DATE: September 16, 2024

**TO:** CEO Michael L. Thurmond Dekalb County  
**ATTN TO:** Aprell King, Planner, Dekalb County  
**FROM:** Mike Alexander, COO, Atlanta Regional Commission  
**RE:** Development of Regional Impact (DRI) Review

**Name of Proposal:** Clifton Springs Mixed Use DRI 4109

**Description:** A regional DRI review of a project to construct a mixed-use development consisting of approximately 666 multifamily residential units, 101 townhomes, 20,000 SF of medical office space, 12,200 SF of retail space, and 4,000 SF restaurant space.

# DRI SITE PLAN

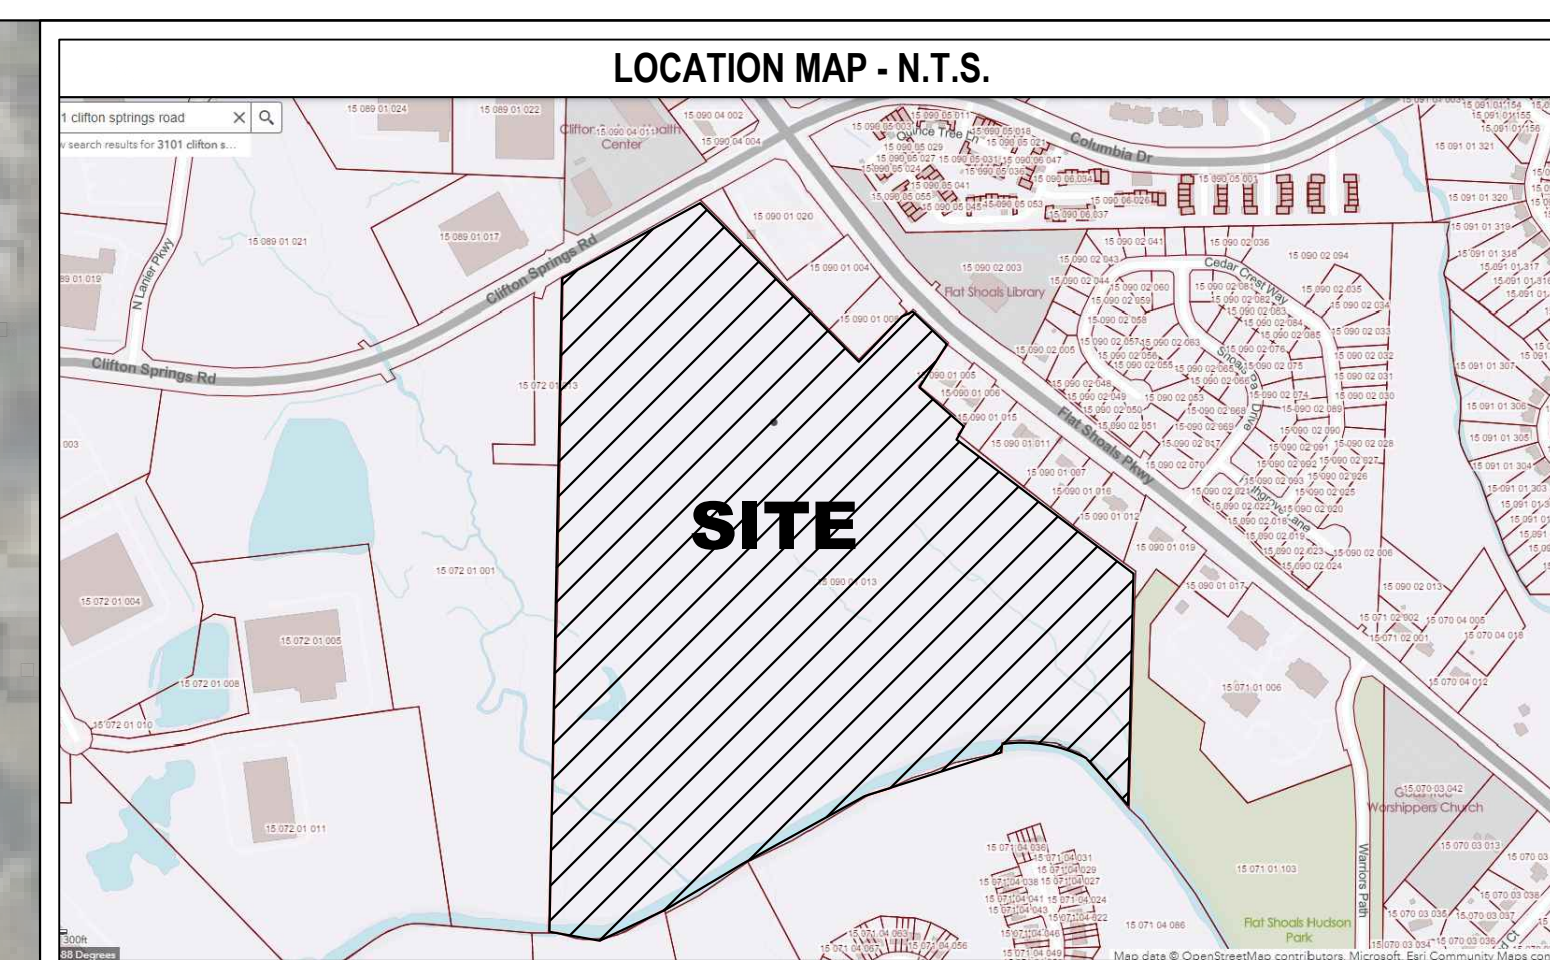
Care should be taken in creating the final plan to utilize basic urban design principles that enhance placemaking and support pedestrian activity. The office and restaurant footprints proposed at the driveway D entrance are set back from both the new main entrance street and Flat Shoals Parkway. Both buildings should be placed along with the driveway frontage at a minimum and possibly closer to Flat Shoals Parkway to create an inviting entrance for those arriving by foot or by car which would attract additional customers to the project retail elements. The placement along the street edge of the new central roadway with parking on the sides or the rear will create a sense of place and encourage pedestrian access. The placement of these buildings as shown in the current plan only perpetuates widely acknowledged urban planning failures of the 1970's and 80's. Many jurisdictions are struggling to retrofit solely vehicularly oriented suburban development patterns like this and constructing new ones is inconsistent with multiple regional development policies.

While sidewalks are generally provided in some areas of the project, their placement and width is unclear from the plans. Further, there are some key blocks where no sidewalks are provided which is in direct opposition to the need to provide pedestrian access to destinations both within the project and within a walkable distance. In particular, pedestrian access from various points within the project to the Quick Trip convenience store just a block or two away is limited or even non-existent which is in direct opposition to regional multi-modal transportation and walkable neighborhood policies.

The South River forms the southern boundary of the project property, as shown on the project site plan. Both the USGS coverage for the project area and the submitted site plan show one blue-line stream crossing the southwestern corner of the property. Neither the 25-foot State Sediment and Erosion buffer nor the County 75-foot stream buffer are shown along the stream or along the South River. While none of the proposed development is shown near either the stream or the South River, the buffers should be shown to indicate their presence for project revisions or future development.
